**HARDY COUNTY PUBLIC SERVICE DISTRICT
HARDY COUNTY, WEST VIRGINIA**

PROPOSED NEW OFFICE FACILITY

ADDENDUM #2

September 13, 2022

C-5.0

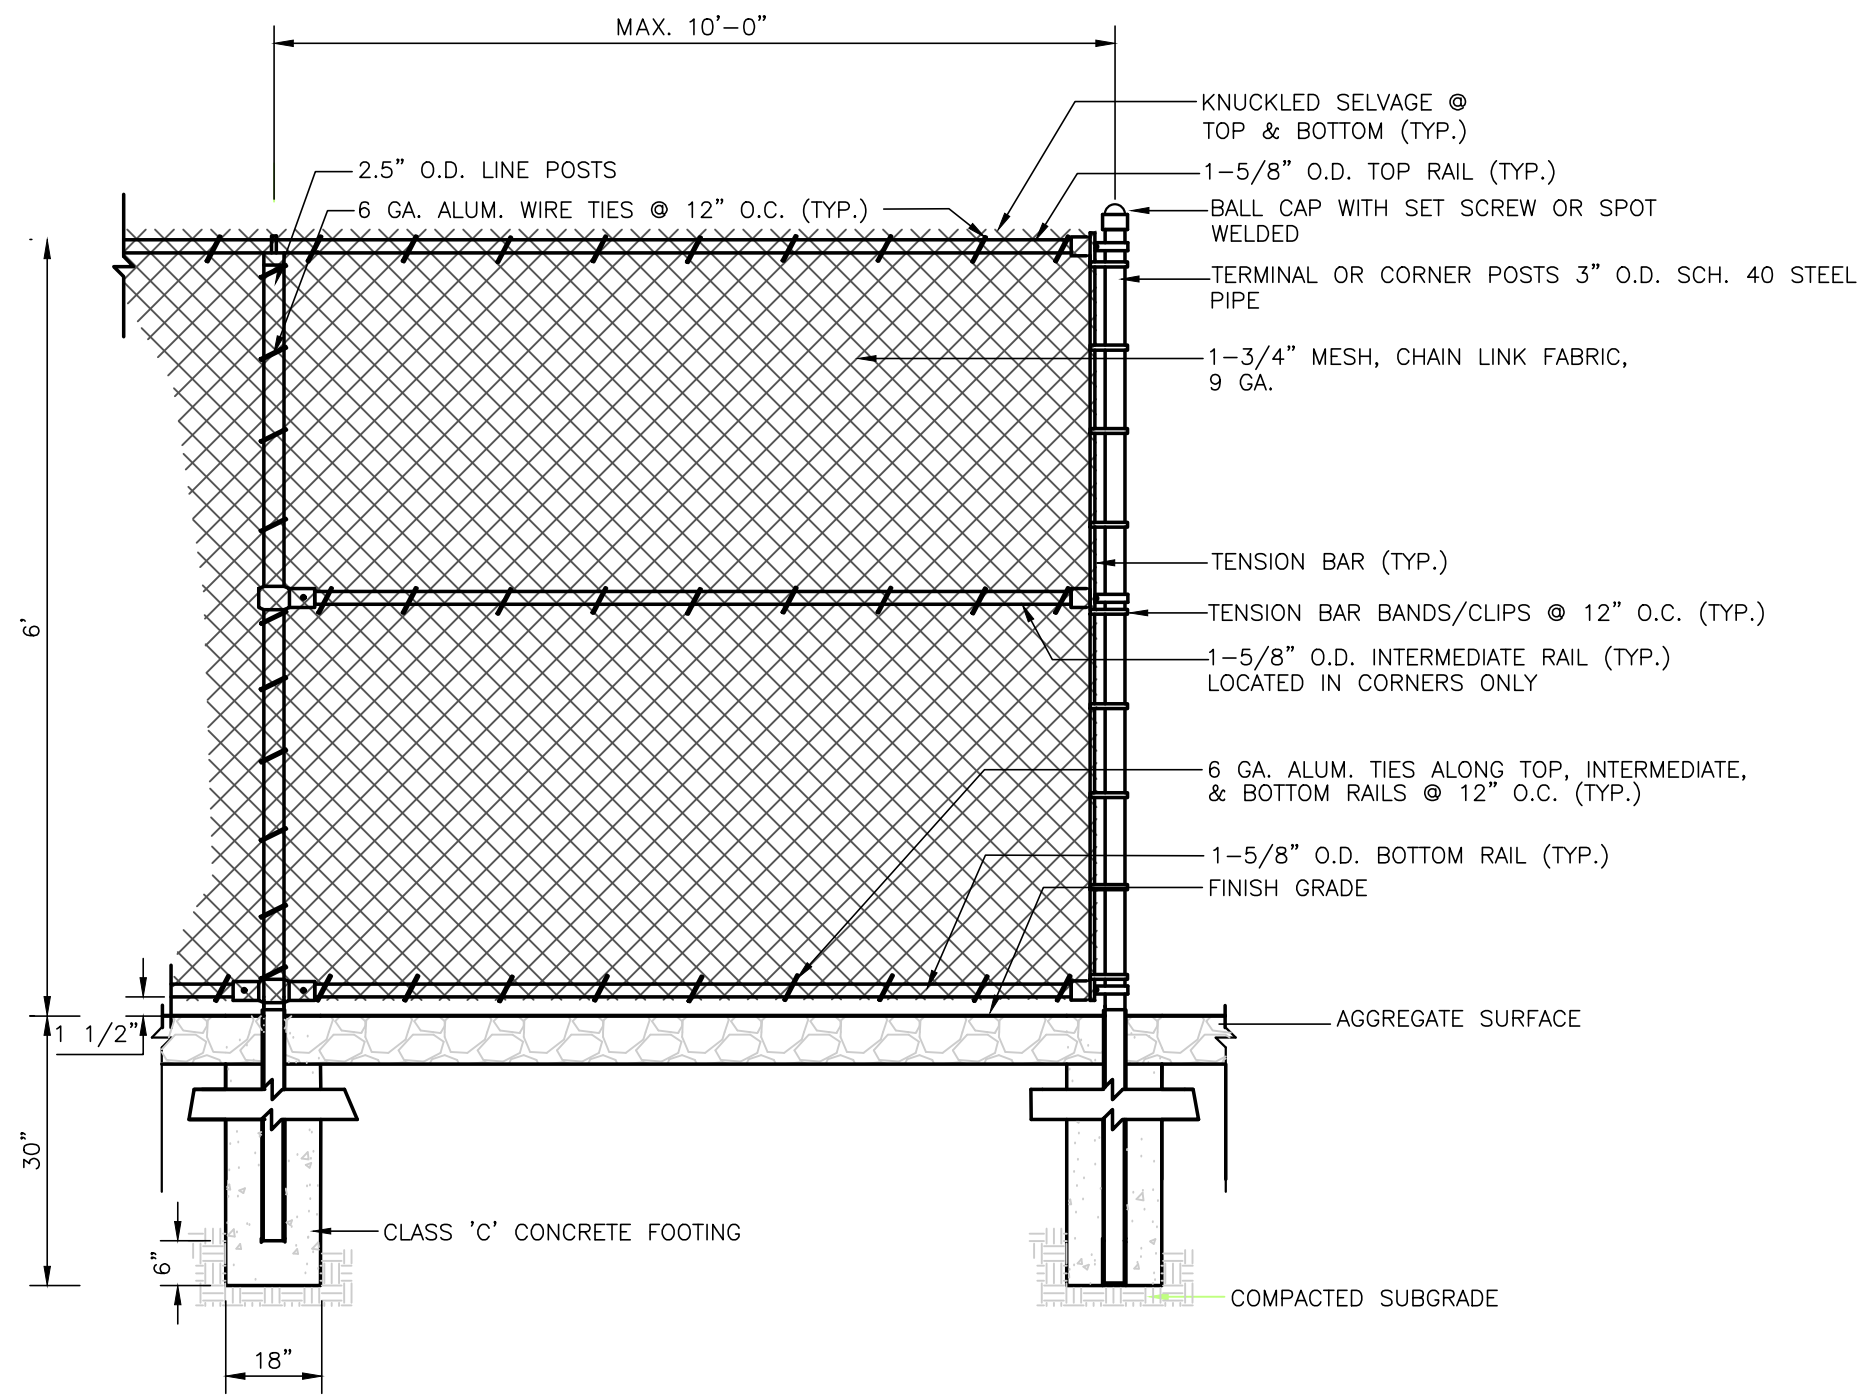
Question 5. On sheet C-7.3 a detail is shown for underground utility conduits. Please clarify where the utility conduits originate from (pole, etc.).

4	PAE	09.12.2022	UTILITIES LOCATION UPDATED AND COORDINATION NOTE 4 ADDED
NO.	BY	DATE	DESCRIPTION

Response 5. See Attached Revised C-5.0 Utility Site Plan showing the existing utility pole location and proposed new conduit sizes and locations for new underground electric service conduit and conductors, and new fiber optic conduit with pull cable. Also see the revised Plan Note #4 regarding contacting the utility providers to confirm that these installations comply with their requirements.

SHEET No.
C-7.7

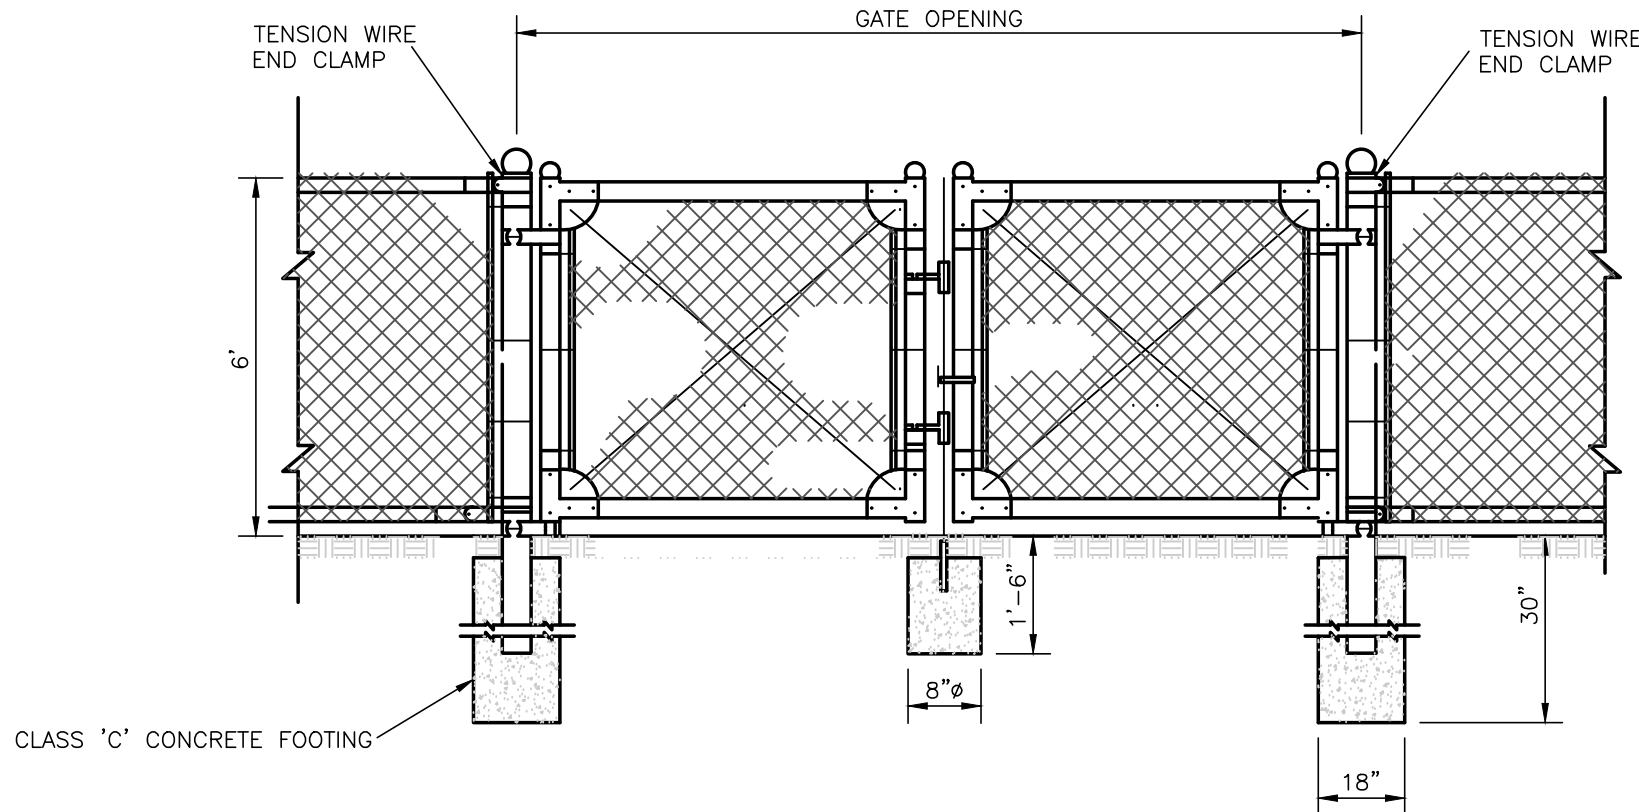
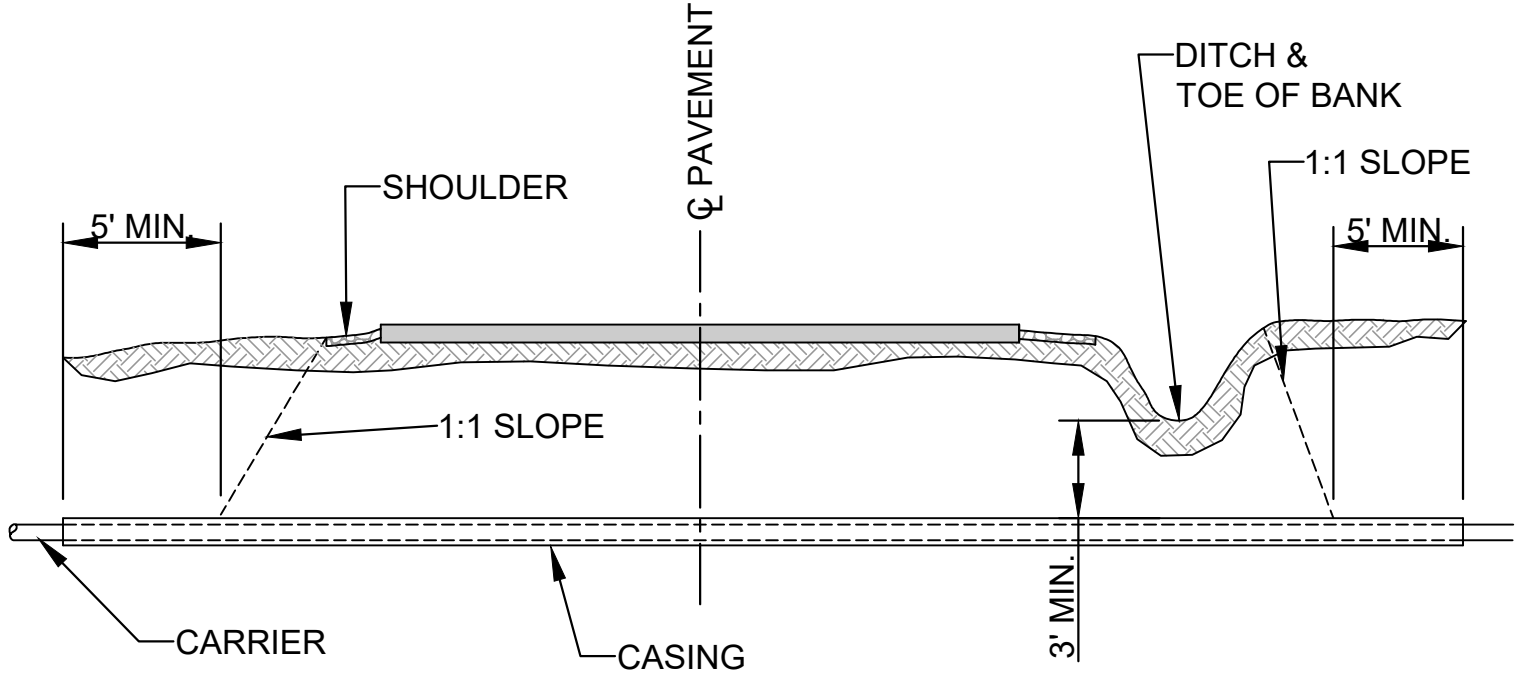
Question 23. The fence contractors bidding the project say the chain-link fence is not typical of Thrasher. It appears to be a "Tennis Court" fence detail, which is significantly higher in price.

1	PAE	04.08.2022	Addendum 1-Fence height
4	PAE	09.12.2022	Fence height, posts diameter, concrete depth. Gas line bore detail added.
NO.	BY	DATE	DESCRIPTION

Response 23. Without more specific information, the fencing and gate details shown on Drawing C-7.7 appear to be standard and shall be maintained.
